SERVICE BULLETIN

Bulletin No. SVB-166

Model JX-50

Subject CLUTCH LEVER
PULL

Picture #1

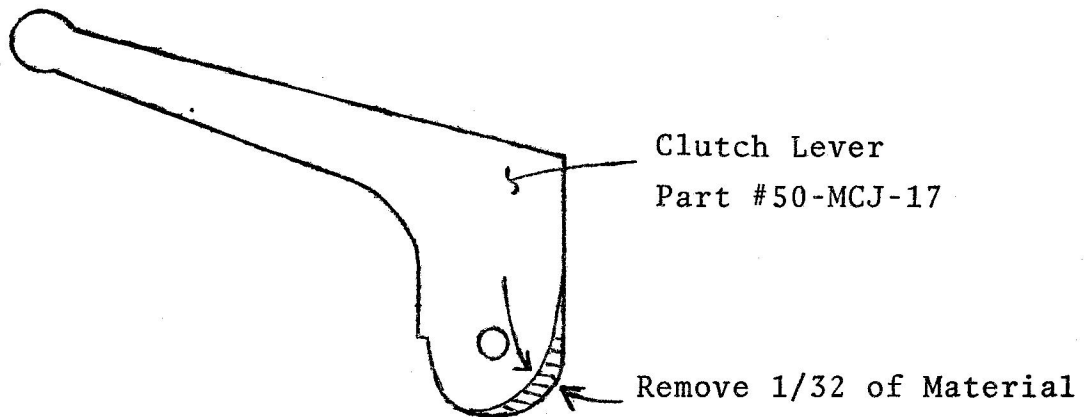
1. Remove the clutch lever and clutch cable from the motorcycle.
2. Grind off the material indicated (picture) from the clutch lever. This prevents the lever from binding against the clutch lever bracket.

3. Grease the lever "pin" and "rub" parts and replace the lever back on to the clutch lever bracket.
4. Replace the standard clutch cable with cable #74-0170. This is a throttle cable that has less friction than a normal clutch cable. You must modify the new cable as follows:
 - A. Unsolder the small ball end of the cable.
 - B. Pull the inner cable out of the outer cable housing.
 - C. Discard the cable adjuster and small ball end.
 - D. Cut the outer cable off to be 30" long overall.
 - E. Lubricate and reassemble the cable back on to the clutch lever.
